RE: Data Responses, Set 4A
Cosumnes Power Plant (01-AFC-19)

**COSUMNES POWER PLANT
(01-AFC-19)**

DATA RESPONSE, SET 4A

COSUMNES POWER PLANT (01-AFC-19)
DATA REQUESTS, SET 4A

Figure 1

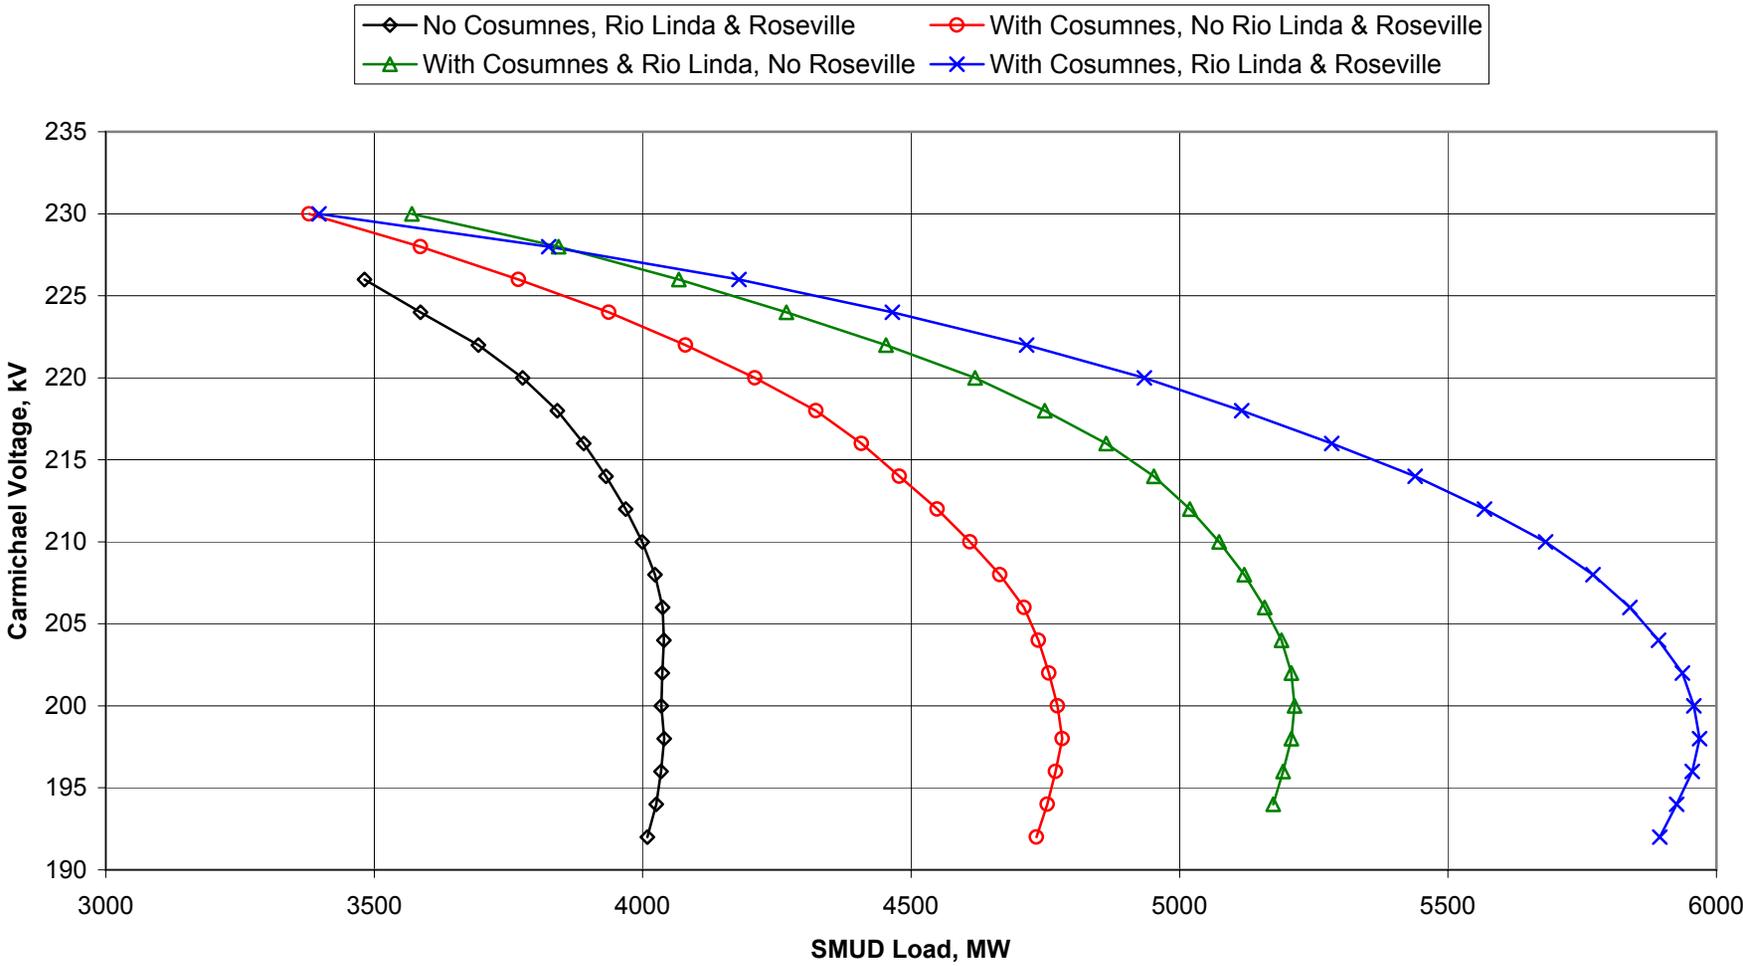
257. Please provide voltage support analysis, including impacts/benefits of all the proposed generation additions.

It is feasible to perform a generalized sensitivity study involving the Roseville Energy Center however, and the results are shown in the attached Figure 1, Figure 2 and Figure 3, each showing PV curves that demonstrate the n-0 impacts associated with additions of the Cosumnes Power Plant, the Rio Linda/Elverta Power plant, and the Roseville Energy Center (along with Colusa and East Altimont).

Figure 1 shows the improvements in local voltage support as the various local generation plants are added to the system.
